Lenders' Independent Environmental Consultant: Monitoring Report June 2010 Sakhalin-2 Phase 2 Project

Report to Sakhalin-2 (Phase 2) Project Finance Parties

Restricted – Commercial
AEAT/ENV/R/3052 Issue 1
July 2010

Photo 1 – Vegetation lack and start of silting

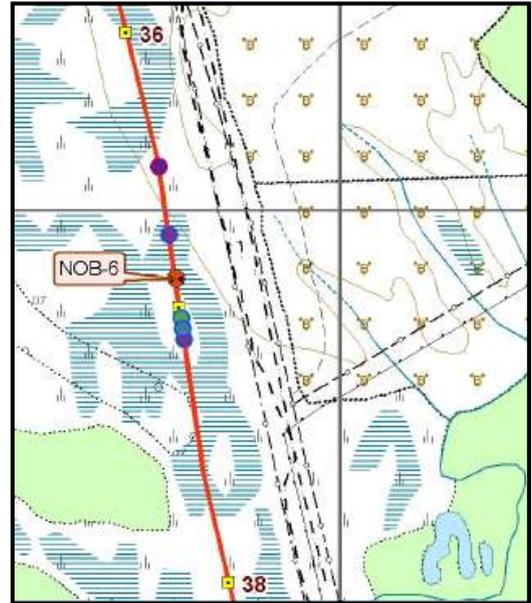
There is an urgent need in this area for further drainage works to control the run-off across the slope and re-seeding / soil protection to prevent further silting.

Photo 1 – Erosion rill at side of access road

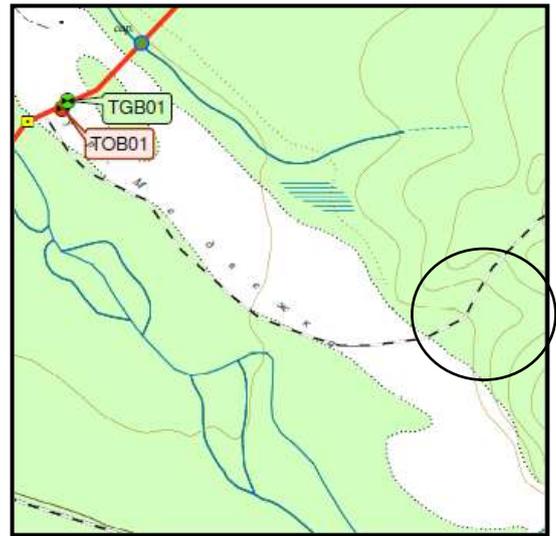
The drainage of the slope run-off needs improvement to prevent further erosion and silt controls, silt fencing or trench breakers, to be installed to stop further silting of the valley floor.

Photo 2 – View of a slope failure at mid slope

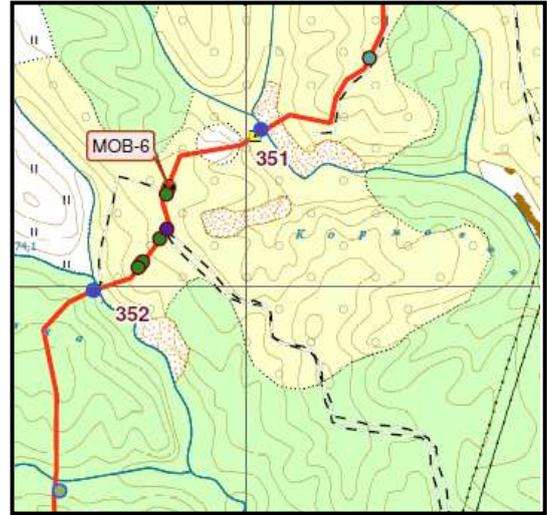
During the visit it was observed that the south slope has generally good surface run-off control but is almost entirely devoid of vegetation (Photos 1 to 3). Also, a significant sized failure was observed at mid slope (Photo 2). The north slope showed evidence of sediment flow to the river along the side cuts. The surface of slope as well the side cuts (which are covered with geotextile) show no vegetation.

Photo 2 – Damaged gabion wall and bridge foundation

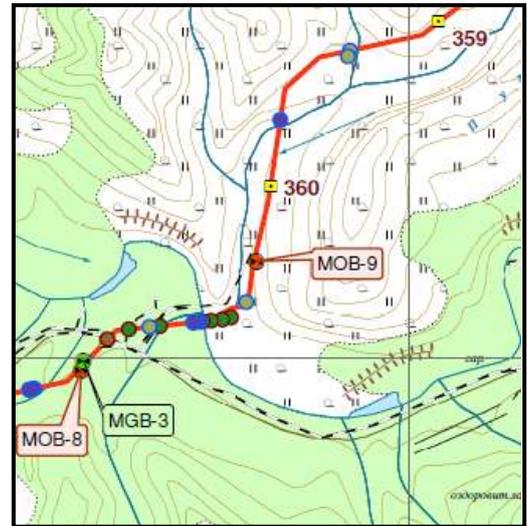
The river bank protection consists of gabion walls on both banks. The north bank gabion wall is damaged at the upstream point and will need repair (Photo 2). The RoW on the north side has a running track leading to the BVS (Photos 1 and 2). Reportedly, the running track will be removed and the slope will be reinstated. The gabion wall on the south bank is intact; however the bank and the RoW to the south have construction debris and a temporary road (Photos 3 and 4). All this is reportedly scheduled to be removed following the spawning period. Vegetation on the RoW to the south is good, and the north RoW will need to be seeded when the slope is reinstated.

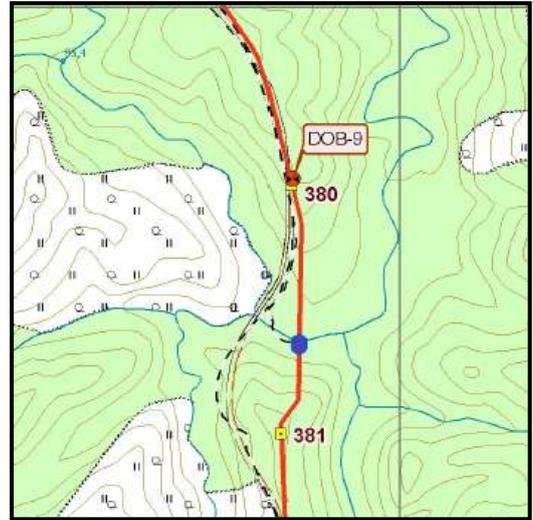
The slope on the south side is very steep and at the time of the visit was partially covered with snow. Soil movement was observed at about mid slope on the gas pipe side (Photos 3 and 4). Reportedly, Company personnel have noted the condition of the slope and added it to the maintenance schedule.

The slope also has very limited grass cover and is in need of further bio-restoration.

Photo 1 – View north showing RoW with slope breakers and very sparse vegetation

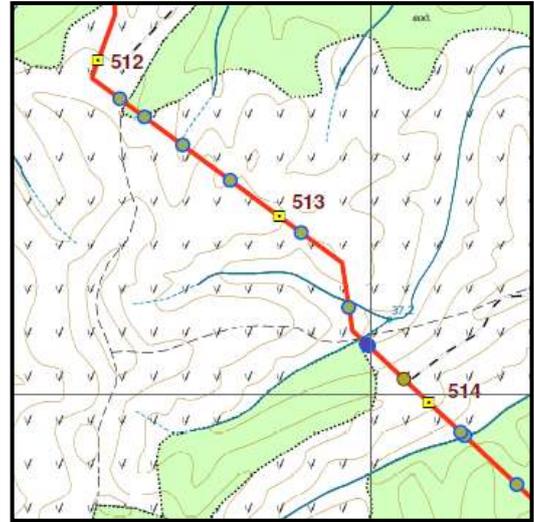
The sandy slopes along the RoW in this area have very inconsistent grass cover, but mostly they are without any vegetation at all (Photos 1 to 6). Much work was done to protect some of the steep slopes with slope breakers and generous use of geotextile. The slopes that were observed during the visit appear to mostly hold well following the typhoon and the thaw, but rills have already started to develop (Photo 3) and with future rains will act as preferential conduits and will grow larger. The area is in need of thorough bio-restoration to prevent future erosion.

Photo 1 – RoW segment with poor grass cover

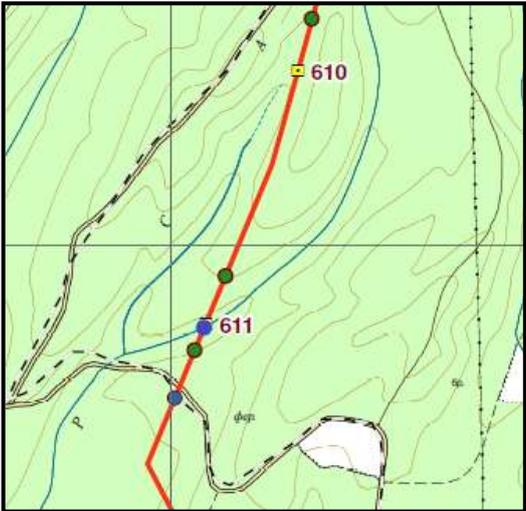
RoW segment at a forestry road crossing, showing poor grass cover. This location is in need of further seeding and application of fertilizer.
